DESIGN RESPONSE

20009DA

104-116 REGENT STREET
REDFERN

09 JUN, 22

FIGURE 1. REGENT ST - ELEVATION

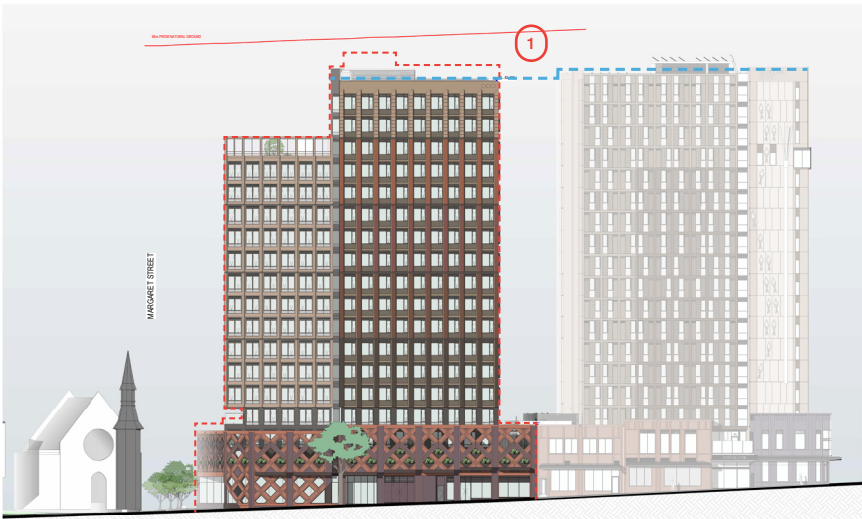
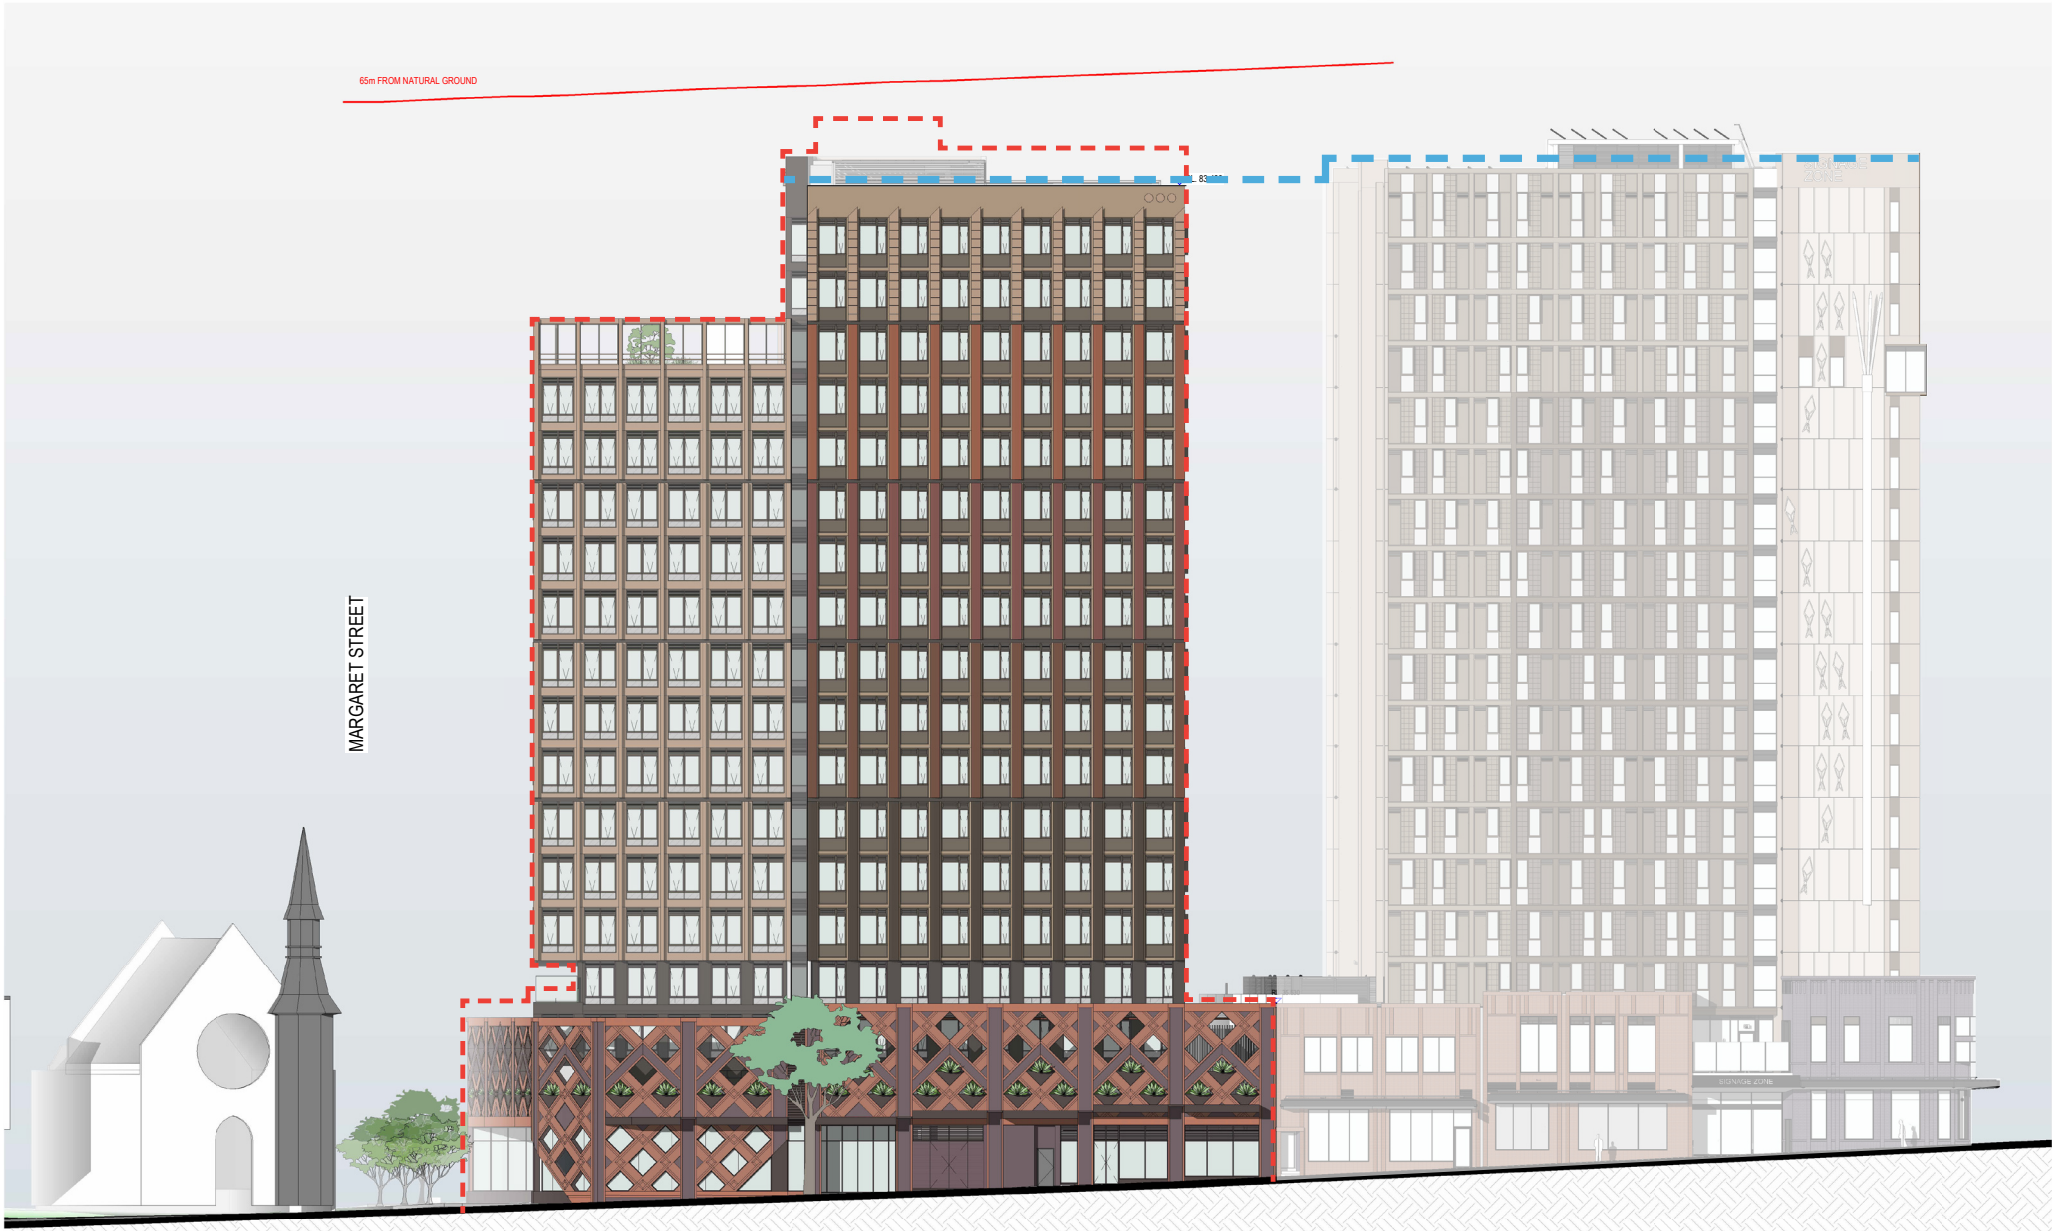
Reduce the height of the building to comply with the 18-storey height limit (noting the proposal currently reads as a 19-storey building) and ensure roof top plant is integrated into the design of the building or appropriately screened

The site prescribes a height of buildings of 18 storeys under SEPP (State Significant Precincts) 2005. The proposal does not comply with the height control and presents a 19-storey development as plant is distributed across the full extent of the tower and contributes to a whole storey of visible bulk and scale. The maximum height is also higher than the development at 90-102 Regent Street, despite being lower in the street due to the fall of the topography.

The City strongly recommends that the maximum height of the tower be lowered to match the neighbouring development, with plant to be designed into an 18-storey tower or substantially setback from the perimeter of the tower to reduce bulk and scale. The development also provides a consistent single height podium, which makes the site appear as monolithic with no correlation to the topography and fine grain character of the locality.

- The rooftop plant setback from the perimeter. Refer previous and amended roof plans showing the plant extent in grey (refer to figure 2)
- Parapet height reduced from 3.55m to 1.5 m(refer to figure 1)
- Metal louvre screens provided to conceal the visible portion of the plant equipment behind.

The change has also brought the height of tower lower than 90-102 Regent St (refer to figure 1)

- 1 Maximum height of the tower reduced to be lower than 90 - 102 Regent Street
- 2 Plant recessed from the perimeter of the tower to reduce bulk and scale

FIGURE 3. REGENT ST - PODIUM WALL

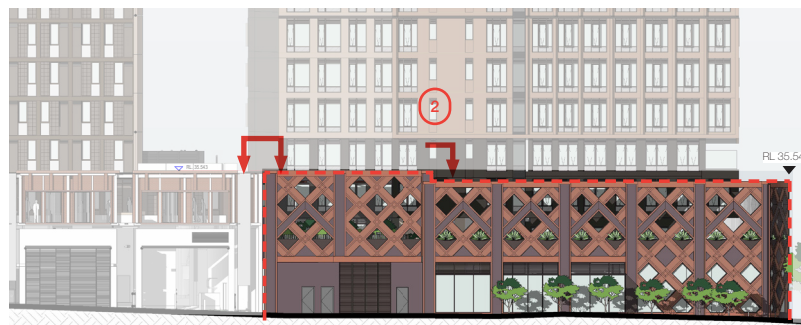
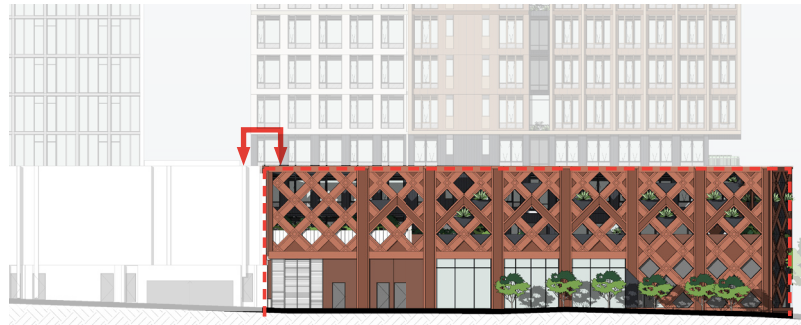
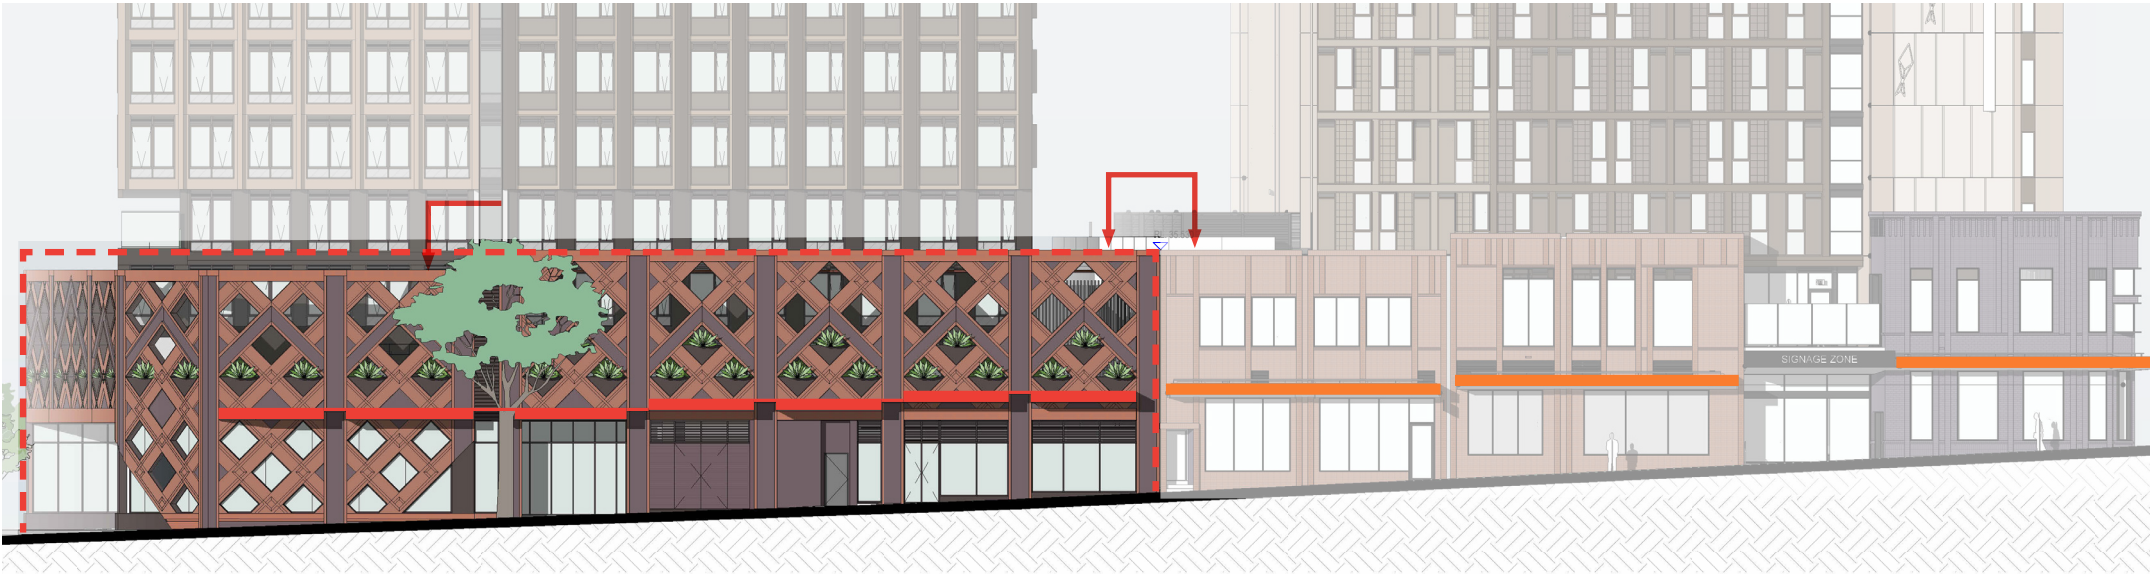
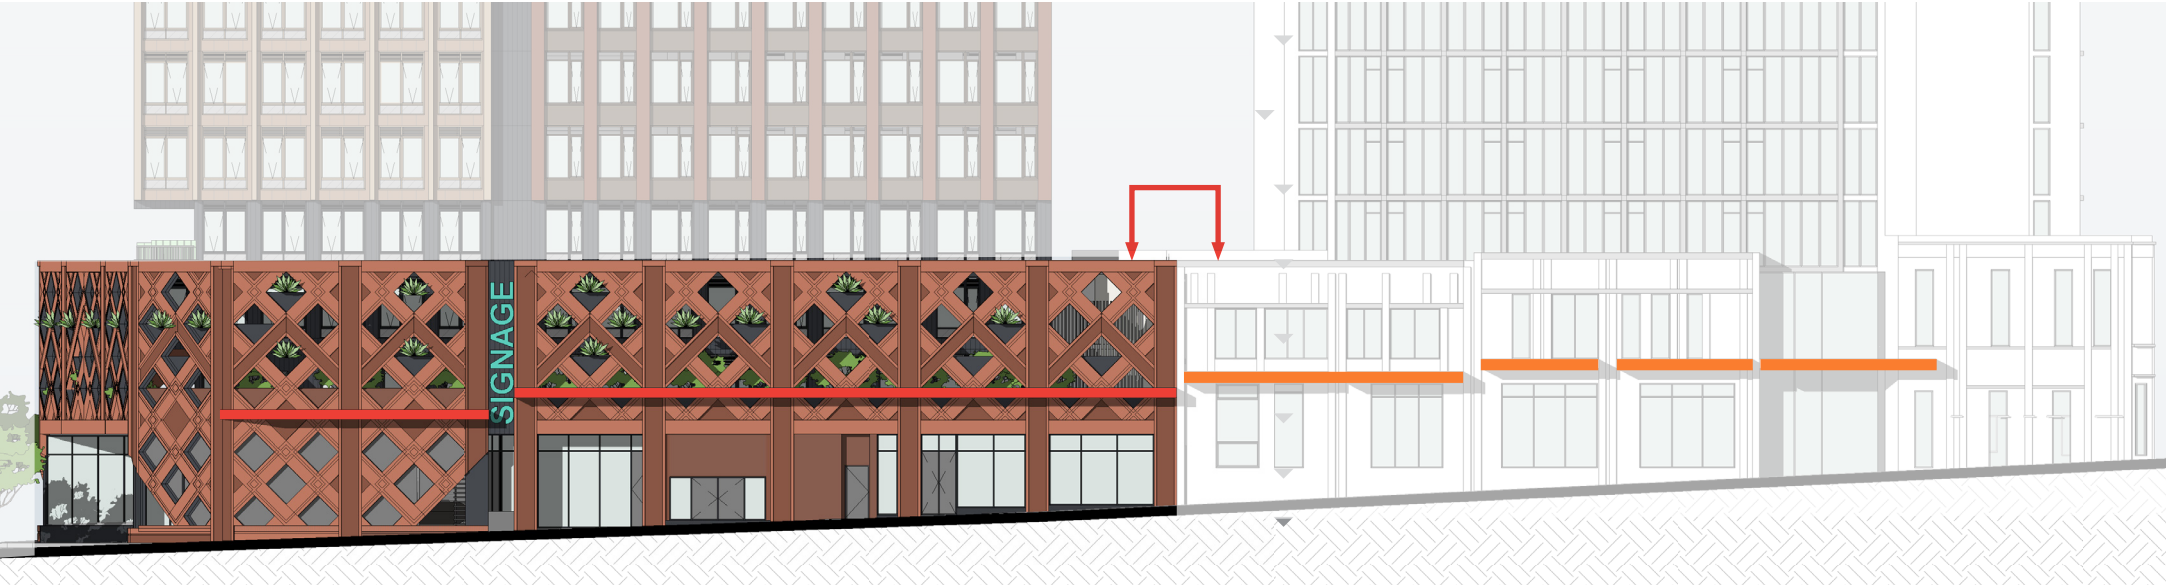
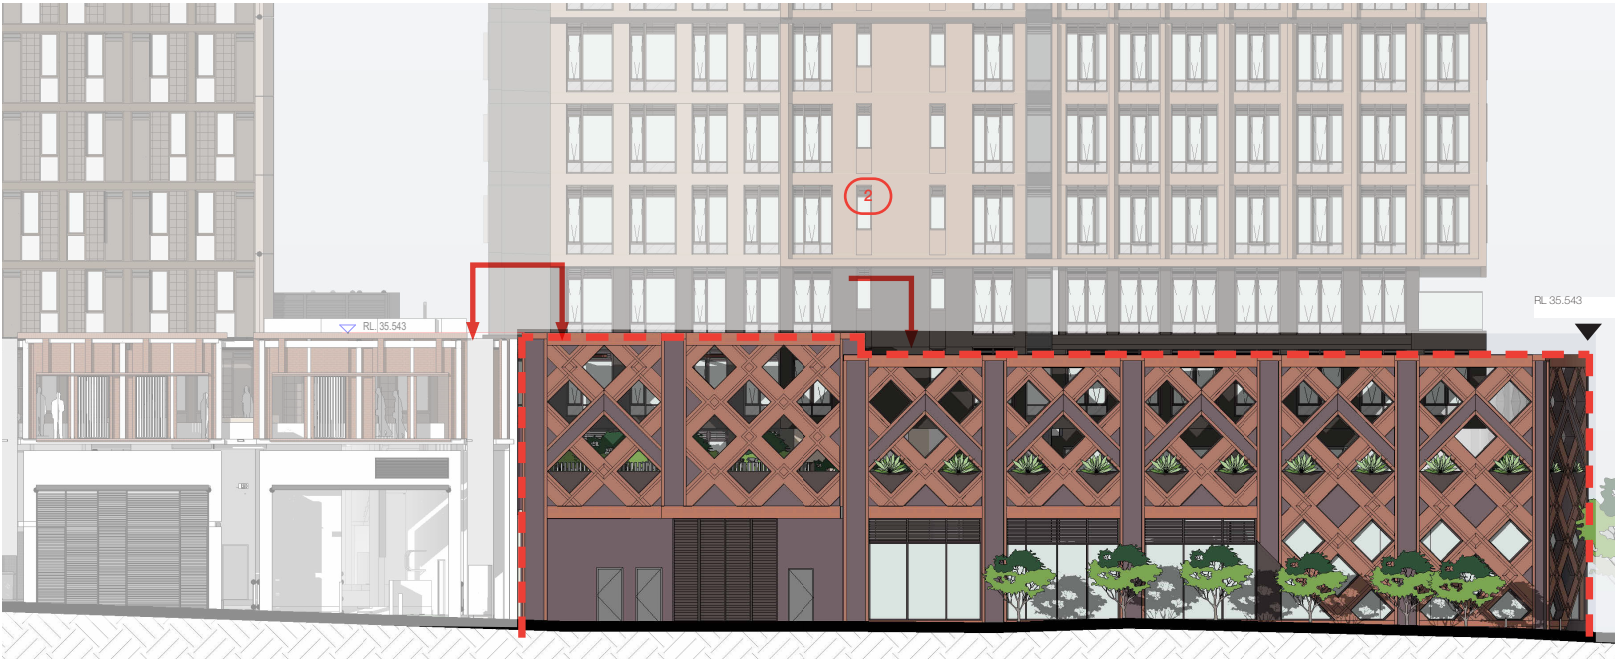
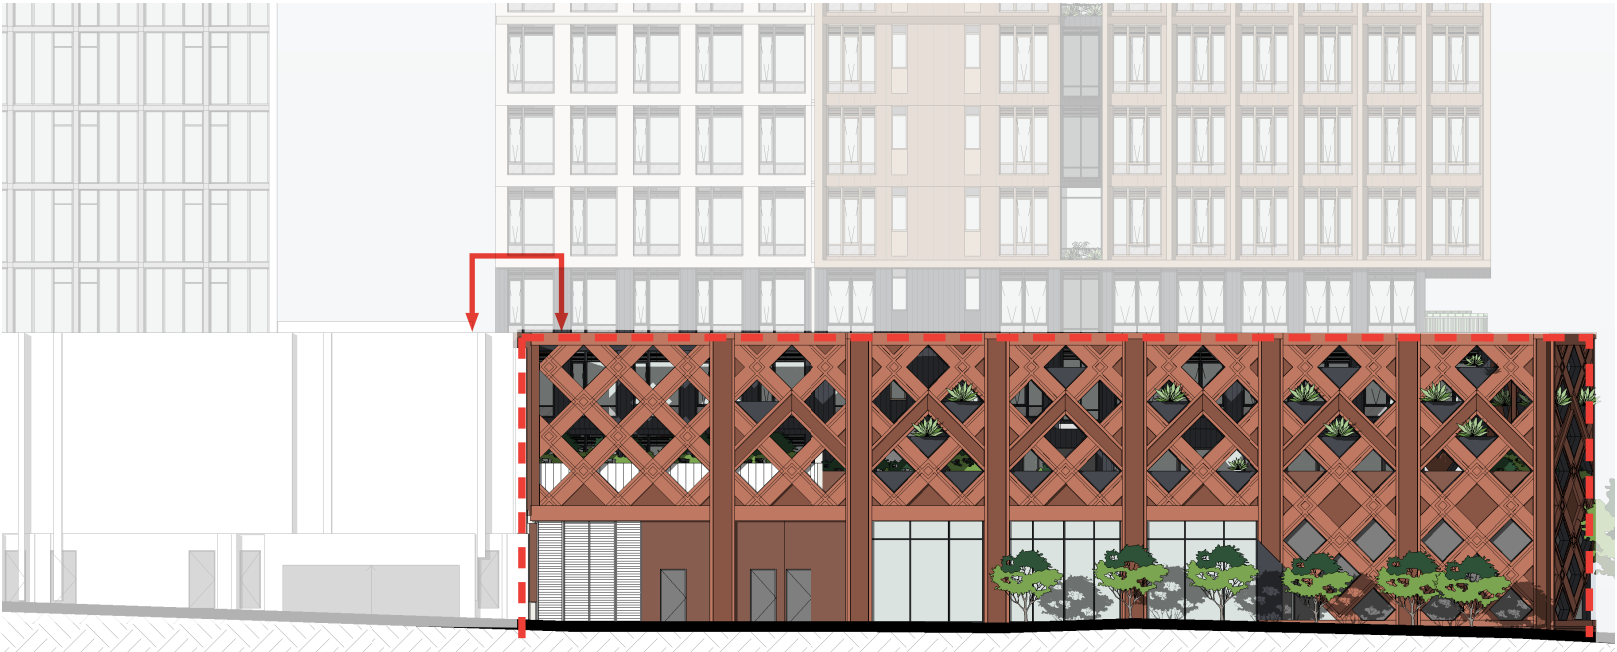
- provide further justification for a three-storey podium along Regent Street and amend the podium to step down in height towards the Church

The podium height is recommended to step in elevation to relate to the topography of Regent Street and the through site link, and to be consistent with neighbouring consents in the streetscape to modulate the scale and bulk.

- Massing of podium looks to integrate with the finer grain and scale of street scape pattern emerging on Regent Street.
- Emphasises the pattern exhibited in grouping of terraces / parapet alignment across each block with modest stepping to relate to topography. (refer to figure 5)
- Maintains relationship of alignment with the neighbouring development 90-102 Regent Street Podium height both on Regent Street and William Ln. (refer to figures 3 & 4)

- ① Podium height stepping to relate to Regent st topography
- ② Podium height stepping to relate to William lane streetscape and topography
- ③ Podium height to follow patterns set by emerging Regent st streetscape

FIGURE 6. BUILDING SEPARATION

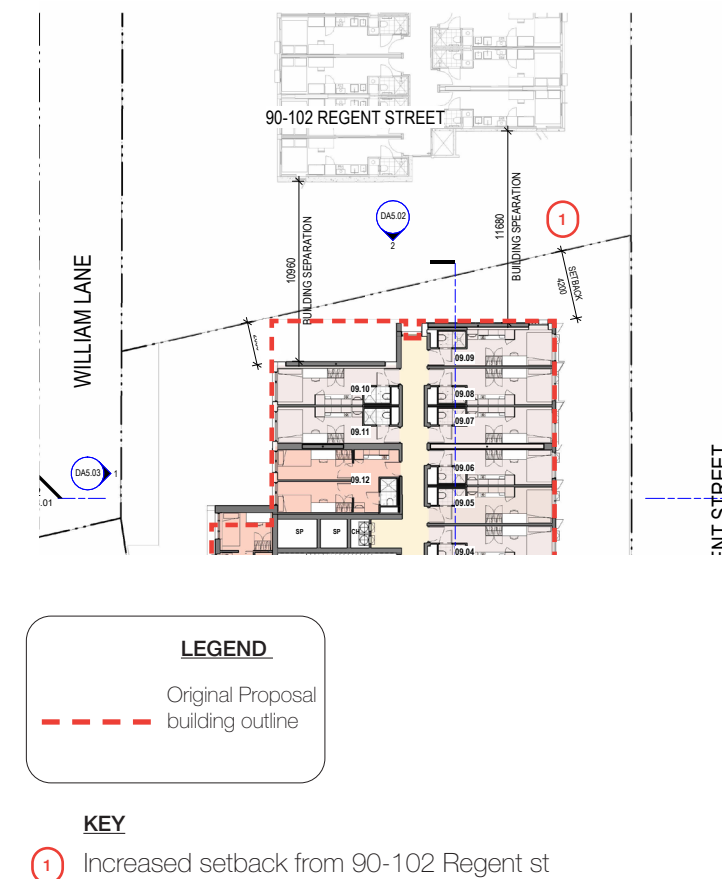
- Increase the podium separation along the western boundary between the proposed development and 13-23 Gibbons Street
- Increase the tower separation along the northern boundary between the proposed development and 90-102 Regent Street.

The tower separation to the north and west do not respond to the recommendations of the RCUDP. The development relies on the building setbacks of neighbouring developments to achieve tower separation. The proposed tower setbacks result in inadequate spacing between buildings in the streetscape, results in loss of view sharing, privacy and acoustic amenity impacts and is not supported by the City.

Specifically, a 9-metre setback is outlined in the RCDP to achieve an 18- metre building separation between developments. At the north-west corner, a party wall condition is proposed with a 0.3m distance from the northern boundary increasing to 4.1m at the north-east. This is the most non-compliant tower separation proposed of the 4 towers on neighbouring sites located within this respective block. The fundamental tower massing strategy was a matter consistently raised by the State Design Review Panel as being inadequately investigated and proves to be the case in the EIS.

Further the revised design proposal has achieved 2.65m set back at the north-west and 4.2m at the north-east, resulting in circa 11m separation from the neighbouring tower. The outcome is considered appropriate when considering other tower separation along Regent streetscape ranging from 11.2m - 17.6m (refer figure 6 -8 showing building separation)
